SR-2 – STAFF ADVISORY REPORT (04-03-2026)

ADDRESS: 1833 CHURCH

APPLICATION NUMBER: HDC2026-00102

SCOPE: DEMOLISH GABLE ROOF OF REAR WING, ERECT SECOND FLOOR REAR ADDITION

Applicant documents

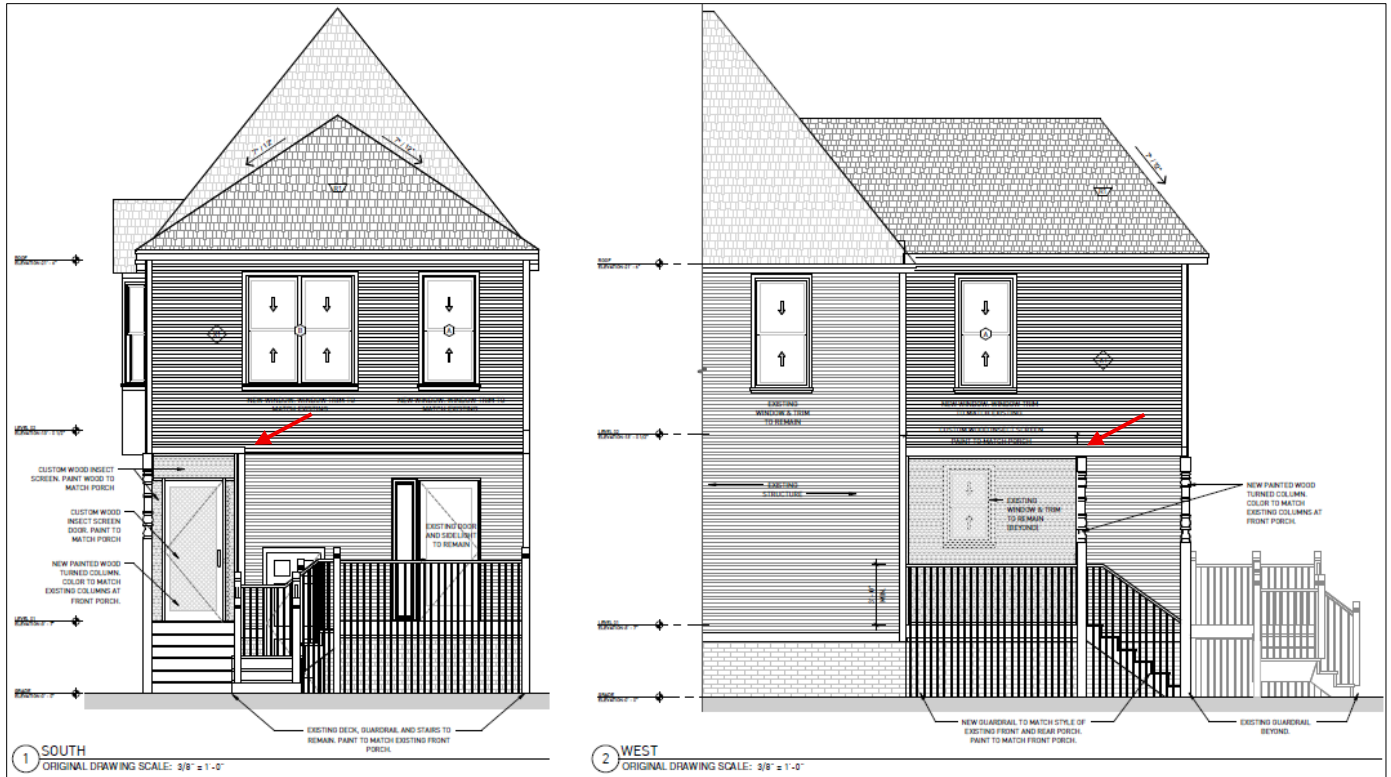
The blue arrows denote the width of the first floor rear wing/second floor addition, the red arrows identify the extension of the roof as covering for the first floor porch.

- The proposed addition fits within the existing width of the historic age rear wing. The roof structure at this location, however, will extend the full width of the main body of the house, creating an open area at the first floor at which a screen porch is planned.
